September 25, 2016

Technical Memorandum

Review Water Quality Certification Materials, Proposed PennEast Pipeline

Prepared for: Delaware Riverkeeper Network

Figure 1: Snapshot of a portion of RR7 Figure 7.1-1 showing soils along the proposed pipeline, MP 29.5 to MP 31.8.

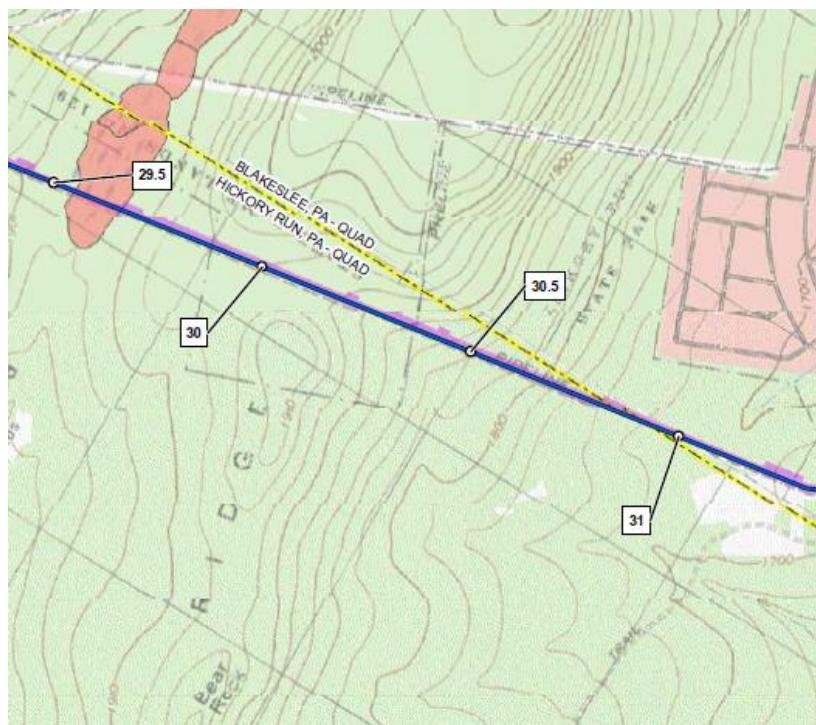
Individual reaches shown in Table 1 are mostly less than 0.3 miles in length, with a 0.8 mile reach at MP 30.1 being an exception. Details of these areas would help determine the significance of the impact. Knowing depth to bedrock is essential because it defines the thickness through which groundwater flow would occur, but the presentation of such information in RR6 is very poor, with depth to bedrock provided only as related to soil types without mile posts (RR6, Table 6.3-4). Starting at MP 29.5 is a series of high compactable soils through MP31.2 (Table 1 and Figure 1). This reach is generally up and down the slopes of a ridge in Hickory Mountain State Park so runoff would be straight downhill. Pipeline construction would cause a strip of decreased recharge and increased overland flow. Recharge along the pipeline from about MP 29.6 to 30.0 would directly support the wetland centered at MP 29.6 (Figure 2). Recharge varies from 20 to 22.2 in/y in this area (Figure 2.2.4-1, RR2), so pipeline construction would reduce recharge (and inflow to the wetland) by as much as 4.4 af/y (0.006 cfs or 2.8 gpm). Based on the size of the wetland, the area affected by the pipeline appears to be a couple percent of its tributary area, but the effect of losing it would depend on the connectivity of parts of the wetland.

Figure 3: Snapshot of wetlands map (Appendix D, p 26 of 32).

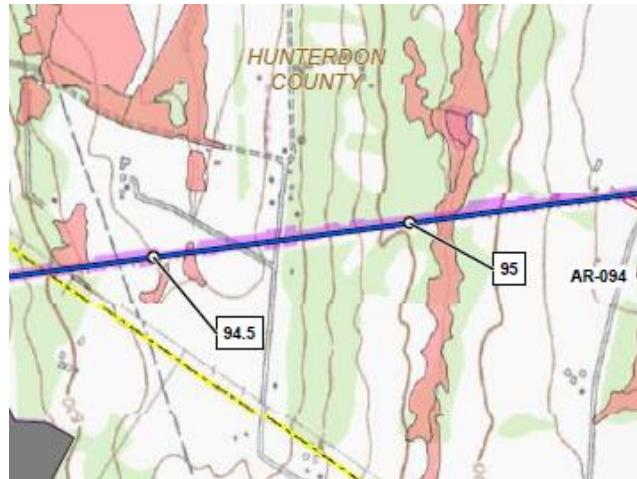
At least 0.2 miles of compactible soil between MP 94.5 and MP 95.1 would reduce flow to the wetlands MP 95.1 (Figure 3). The soil is Croton silt loam (Figure 4). Other wetlands cross or bound the pipeline

near MP 94.5 (Figure 3). The pipeline could intercept recharge either percolating at these points or flowing to the wetlands through shallow groundwater.

Figure 5: Snapshot of soils map from MP 33.8 to 35.2 (RR7, Figure 7.1-1).

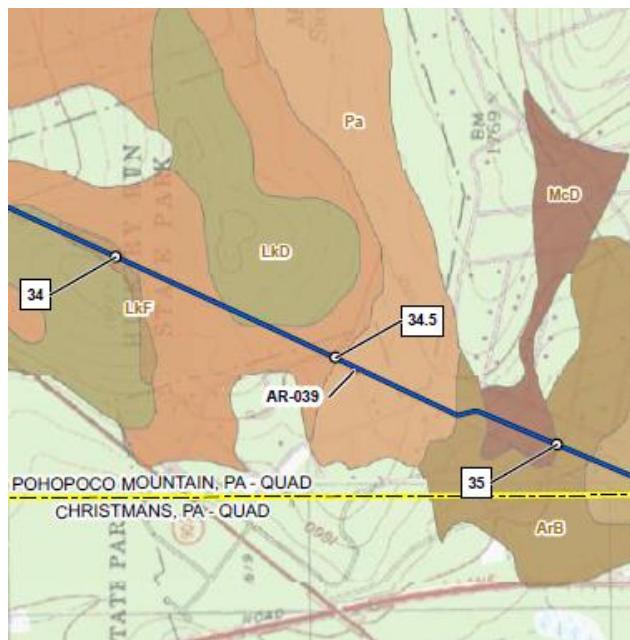
Compactable soils from MP 34.5 through 34.8 control drainage to both sides of a wetland at MP 35.6 (Figures 5 and 6). If compaction eliminates up to 3.3 af/y of recharge that supports a wetlands not much larger than 3.3 acres (Figure 6), the water balance of the wetlands would be considerably changed and the wetland would become impacted by drought. Groundwater quality impacts affected by water balance would be worsened by the pipeline.

Figure 7: Snapshot of wetlands map (Appendix D, p 14 of 32).

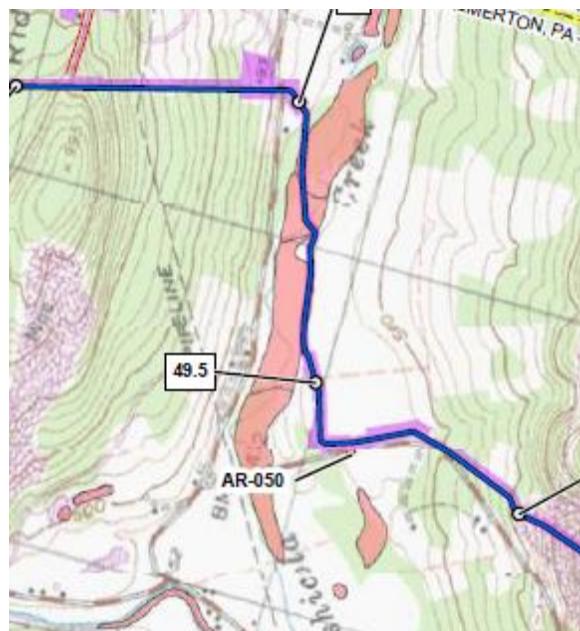
Compactable soils from MP 49 to 49.4 coincide with wetlands between the same mile posts along the Aquashicola Creek. (Figure 7). This section will be in the floodplain of Aquashicola Creek in Papakating silty loam (Table 1), which is considered poorly draining. Compaction in this soil at this area may not affect recharge as much as it will prevent recharge from the south from reaching the creek. The trench would create a barrier that segments the floodplain. Considering the width of the floodplain area with a compacted trench bisecting it, the pipeline could cause geomorphic impacts during flood events. The stream could be captured by the trench or shifted from side to side. Groundwater forced to the surface by the trench could form small channels near the pipeline.

Figure 8: Snapshot of soils map (RR7, Figure 2.1-1) showing MP 7.0 to 10.0. Soil SM is strip mine.

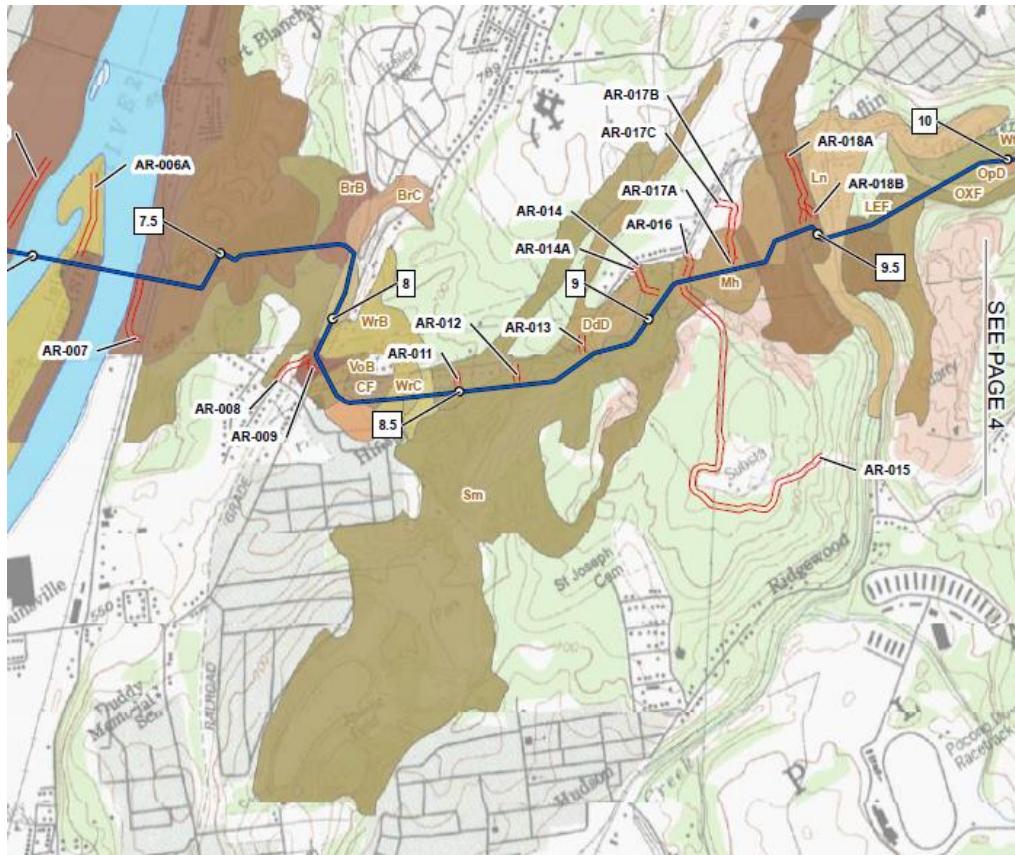
Beginning at about MP 5.1 and continuing to MP 11.2, the soils table (RR7, Table 7.1-1) lists pipeline reaches as having soils classified as “mine dump” or strip mine, burned”. The geology section notes strip mines in this area (RR6, p 6-22). Partially shown on Figure 8, these soils cover substantial areas on the east side of the Susquehanna River crossing. Excavating or otherwise disturbing mine spoil can release contaminants, including acid mine drainage if sulfides are present. The primary mineral of concern, apparently, is arsenic (Id.). The mine spoil is highly conductive (RR7, p 7-15), so the potential for contaminants released by construction disturbance is relatively high. It has the potential for high erosion when disturbed (RR7, p 7-16). The report states that “PennEast is developing a Karst Mitigation Plan” (RR6, p 6-46, emphasis added) which means the impacts of the pipeline due to encountering karst is not known. It is not appropriate to publish an environmental study for review without having the more important aspects of the geology to be affected by the project not understood.

- The PennEast application does not assess the potential for pipeline construction to generate acid generation or leach arsenic in areas where it crosses mine spoil. The application was submitted before they completed relevant studies. The application should be revised to address the potential impact of acid drainage and arsenic leaching and specify appropriate monitoring and mitigation.

Figure 9: National Wetlands Inventory map of the proposed PennEast Pipeline along the Aquashicola Creek.

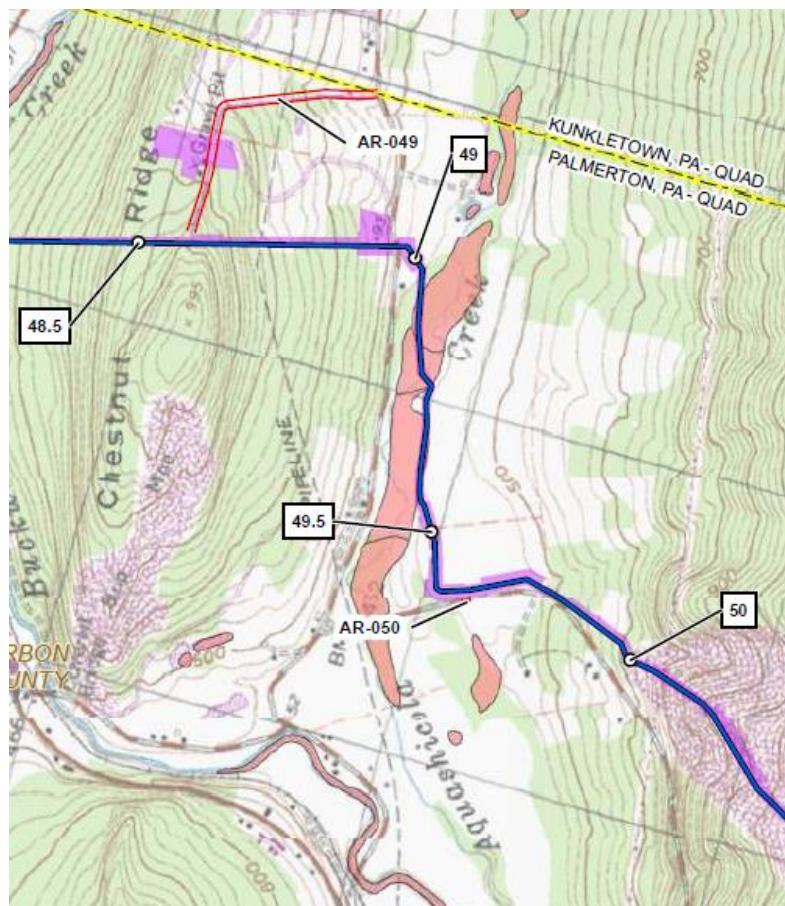
Aquashicola Creek Crossing (MP 49 to 49.7): The proposed preferred route crosses an extensive wetland and parallels Aquashicola Creek for more than half a mile (Figure 9). The proposed preferred route appears to almost maximize the area of wetlands and floodplain affected by the pipeline. The

pipeline crossing the floodplain could significantly divert groundwater flow and affect wetland water balances and baseflow in the creek. Direct impacts due to construction on the creek are also obvious. The values of the wetlands on the floodplain are obvious from a site visit, with Aquashicola Creek meandering through dense shrub/herbaceous vegetation (Photo 2).

- Penn East should consider extending the straight reach from MP48.5 to 49.0 another approximate 0.2 miles across the stream, floodplain, and wetlands prior to diverting southward. An obvious location for the new layout to intersect the pipeline would be at about MP 49.75 where the proposed pipeline changes direction to go southeast. This proposal would require negotiating a route through some Blue Mountain Ski Area facilities but this would be less environmentally damaging than the proposed layout. There would also be less potential for construction to disturb polluted groundwater or aerially deposited sediments due to the Palmerton Zinc Pile Superfund Site (EPA 2011). There would be much less impact on wetlands and less direct stream crossing.

Figure 10: Snapshot of proposed pipeline near Monocacy and East Branch Monocacy Creek, near Bath, PA. MP 59.5 to 62.

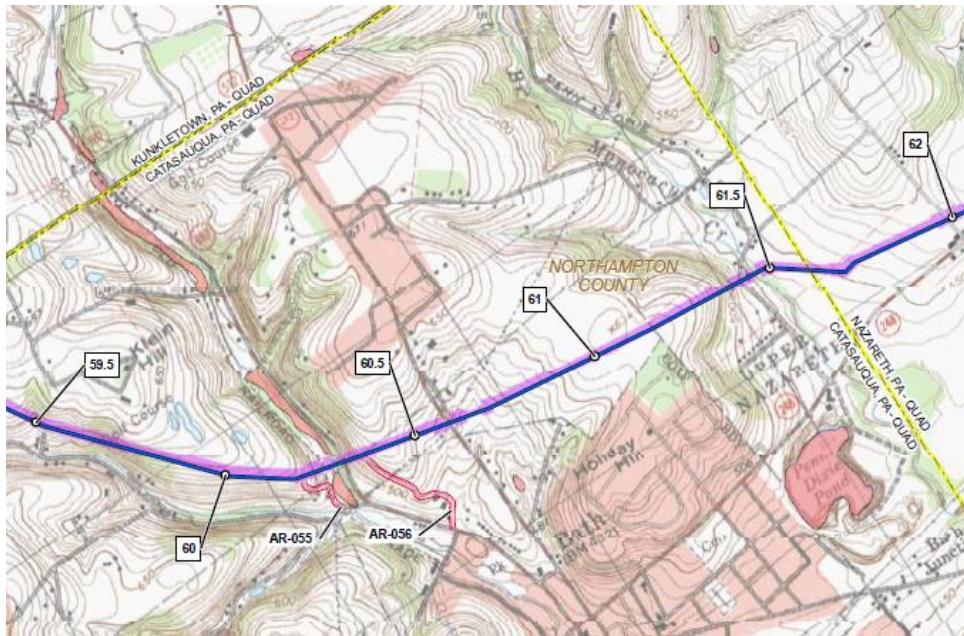
Monocacy Creek, MP 60.0 to 60.5: The pipeline in this vicinity would border on a steep slope southwest of Klein Hill (Figure 10) and cross a broad floodplain with a small stream providing groundwater discharge to Monocacy Creek (Photo 3). The route avoids the White Tail golf course but in so doing it impacts the floodplain (Photo 3) thereby affecting groundwater discharge to Monocacy Creek. Its route along the steep slopes may also cause erosion or intercept groundwater flowing from Klein Hill to the Monocacy Creek tributary (Figure 10). The crossing of East Branch Monocacy Creek near MP 61.5 (Figure 10) also involves the pipeline cutting vertically down a steeper slope.

- Penn East should consider an alternative route through this area to improve the crossing of both creeks just mentioned. Directing the proposed route east across Klein Hill would miss wetlands. All potential routings in this vicinity are in need of greater consideration.

Figure 11: Snapshot of the wetlands map for MP11.5 to 12.5.

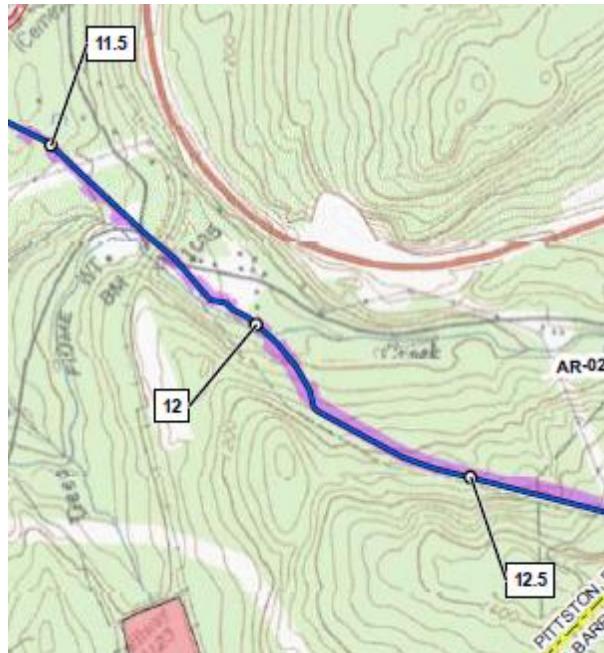
Mill Creek, MP 12.0: Mill Creek near MP 12.0 likely should have a different layout (Figure 11). The proposed pipeline would parallel the stream next to a hillslope for about 0.3 mile (Figure 11). However, most of the alluvium forming the base of the valley lies north of the proposed pipeline. The pipeline trench could likely divert much of the groundwater discharge from the alluvium away from the stream during low flow conditions. A preferred alternative would have the pipeline cut directly across the floodplain at about MP 12.1 and merge with the current layout at MP 11.5.

Figure 12: Map of wetland and topography near MP 29.6.

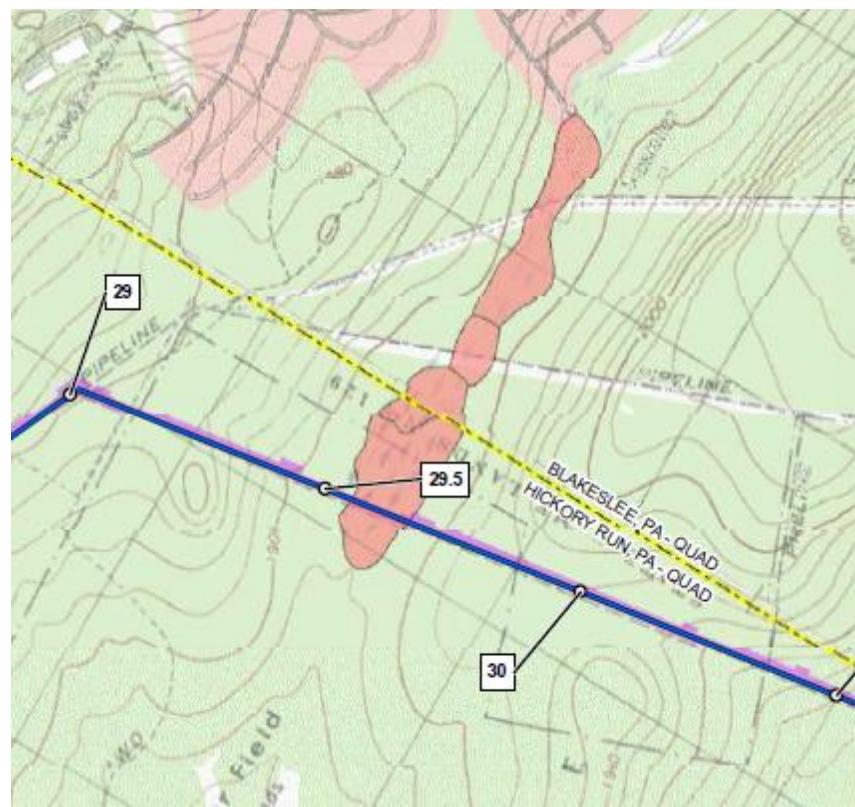
A good example occurs at about MP 29.6 where the pipeline crosses an existing wetland that depends on groundwater for support (Figure 6, Photo 7). There is no obvious surface water inflow, other than storm runoff (Figure 6). The wetland straddles a minor topographic divide, so the area supporting the south end of the wetland is limited. A trench that causes groundwater to surface could significantly change the water balance in the south end of the wetland thereby causing it to be lost due to indirect impacts - indirect being not direct construction but a loss of water.

- At wetlands like this, PennEast should analyze that value of wetlands not lost to trenching if a deeper boring is used to prevent indirect losses of wetlands. They should analyze in this way all significant wetlands crossed by the proposed pipeline.
